8228 GREEN LAKE Dr N, SEATTLE

A Proposed Apartment Development Project for Goodman Real Estate Inc.

DRD RECOMMENDATION #2 MEETING

PROJECT# 3019810

GATEWAY CORNER DEVELOPMENT

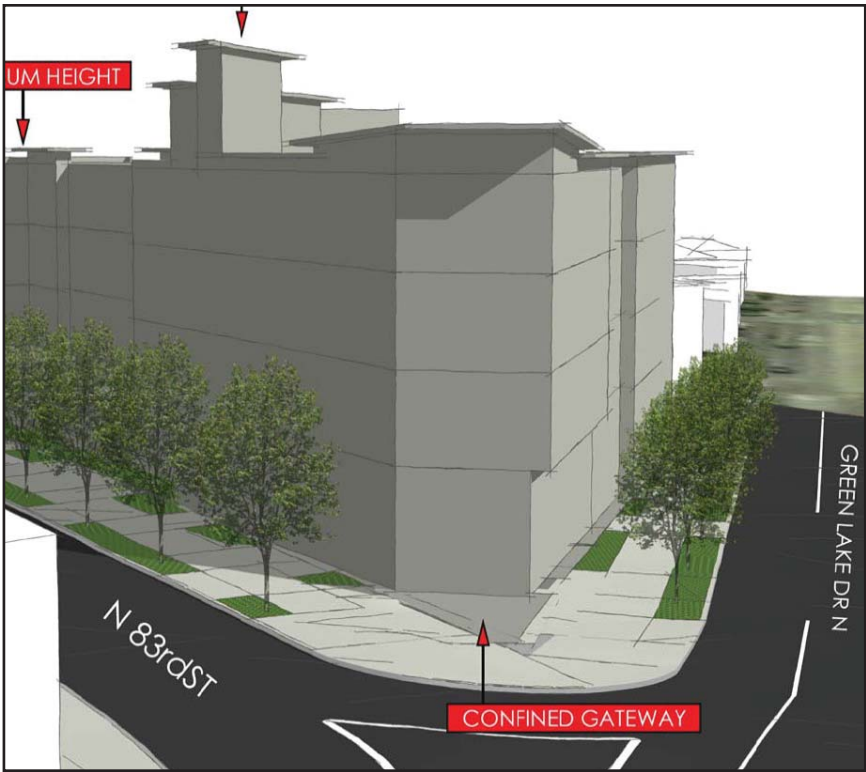
- Provide more presence and articulation
- The building corner should be visually integrated into site
- More detail regarding design concept and relationship of open space

- Architecture and landscaping should read as an integrated response to corner location
- Landscaping should relate to design of building and pedestrian experience
- Use high-quality, durable materials

- Reduced scale of glazing conflicts with art
- Sculptural skin seems contrived and gimmicky
- Real tree at base creates awkward relationship with metal trees silhouette

Building cut at corner to respond to gateway location. Roofing projects outward highlighting prominence of site.

Tallest and proudest corner massing provides presence. Metal band wraps accent-colored wood siding to articulate corner. Concrete columns and glazing integrate base to site.

Laser-cut metal skin connects ground level with upper level focal point massing. Small gateway tree serves as axis for formal street trees. Pedestrian path at corner enhances pedestrian experience.

NORTHWEST CORNER RESIDENTIAL ZONE TRANSITION

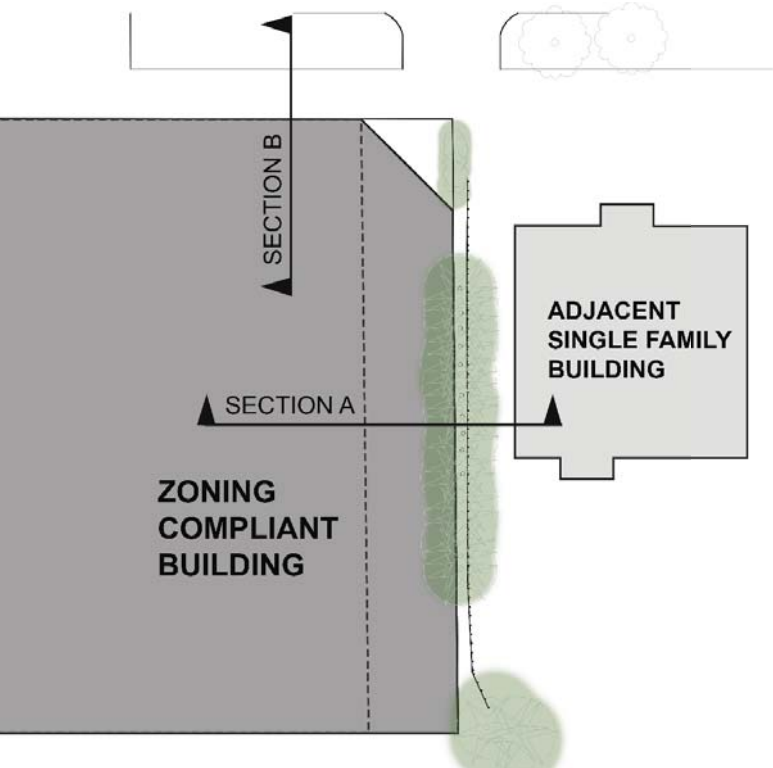
- Provide sensitive transition in height and scale
- Reduce visual bulk of building
- Minimize noise and traffic impacts on N 83rd St

- *Massing demonstrated thoughtful response to corner location/zone transition*
- *Generous setback is appropriate response to context and zone transition*
- Landscaping should engage streetscape and enhance pedestrian experience

- Provide clear setbacks on drawings
- Board suggested pulling in top floor at northwest corner

ZONING TRANSITION AT DRB #2

- 20' UPPER LEVEL EAST SETBACK
- 10' UPPER LEVEL NORTH SETBACK
- VERTICAL BAYS REDUCE BULK

DEPARTURE REQUEST

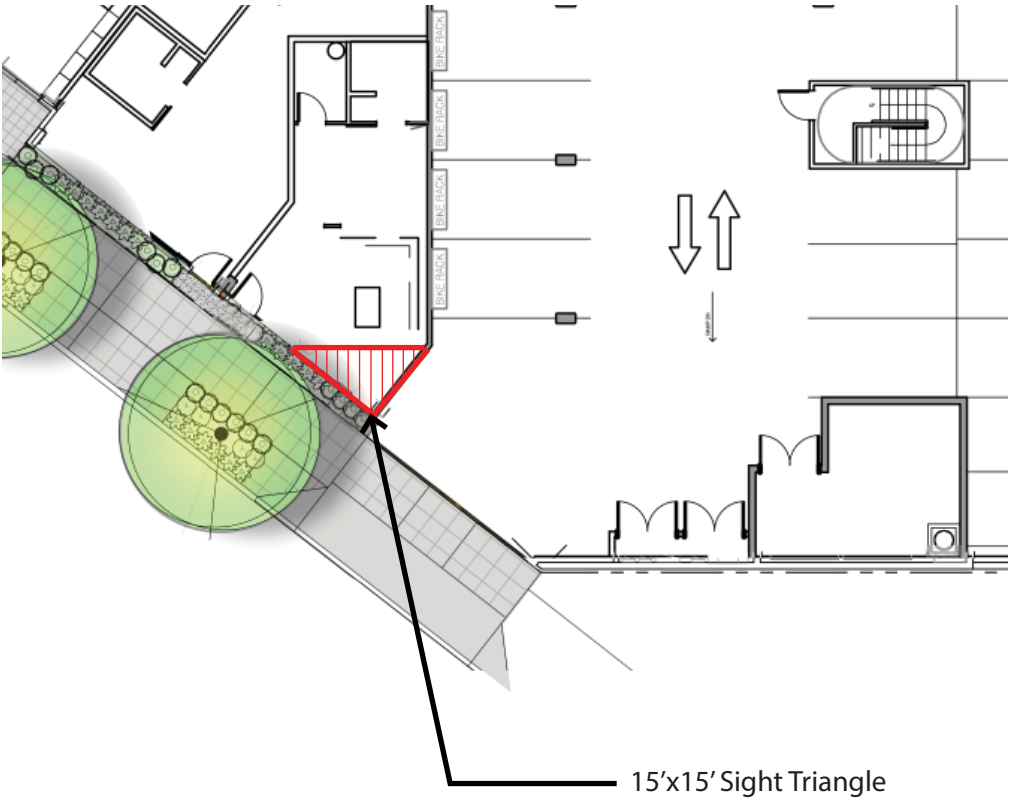
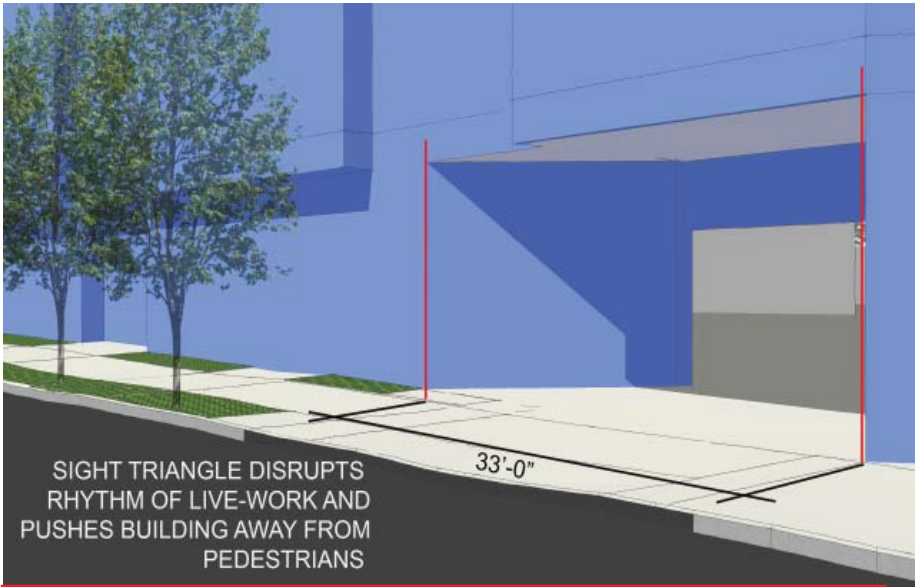
SMC 23.54.030.G.1
-Sight Triangle

Allow alternative measures to meet requirements: convex mirrors and signal lights

Guideline A-8, C-1, C-5: Use of convex mirrors and signal lights, as regularly approved by DPD for use in urban sites, will provide a similar standard of pedestrian safety while at the same time minimizing the visual impact of the parking garage entry and maintaining continuity of commercial facade.

In response to the Boards guidance, the Live-Work entry door has been moved away from the garage entrance. This provides safe access to the commercial space without disrupting the rhythm of the streetfront. The Board was in agreement with this Departure at the DRB #1.
